## **St. Mark's Street Park Working Group (SMSPWG)**

### **Meeting Minutes**

**May 5 2023**

VHB Park Design received May 2, 2023 ("PLAN AND DETAILS FOR SOUTHBOROUGH HISTORY WALK - ST. MARK'S PARK")

#### STONEDUST PATH

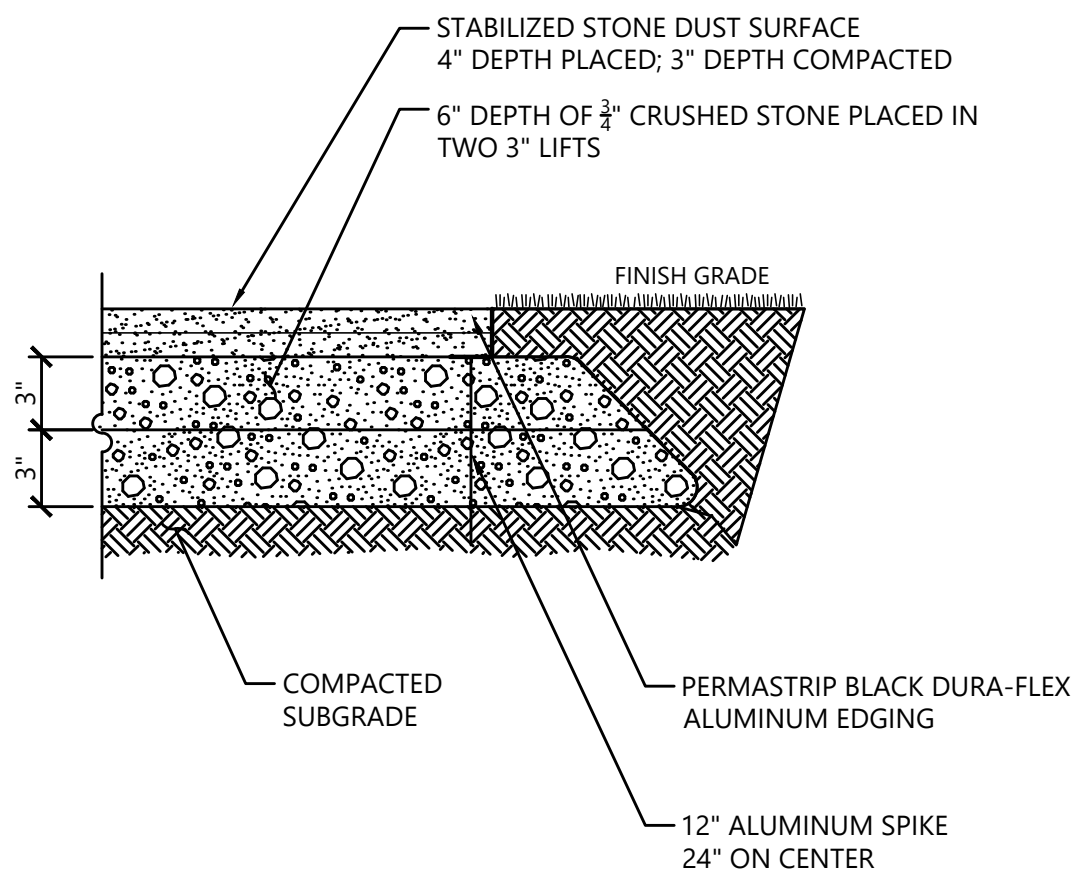
3. Historical Commission secured funding through ARPA for a historical plaque for Southborough Center Historic District in northeastern corner of park
4. Stone walls formerly on parcel to be reconstructed. Walls not included on design being sent out to bid. Possibility to substitute stone fence, like on Town Common, instead of wall. Group requesting specific details on where stone walls will go, even if not included in the same bid.
5. Historical Theme for Park. No plans yet for current historical marker in center of brick plaza, remove "MEDALLION OF GRANITE" in place of future centerpiece
6. Largest trees are all white oaks, seven white spruces as windbreak. Group will ask for input on tree choices
7. Group has question about permeability of crushed granite paths, clarifications on width/radius of paths
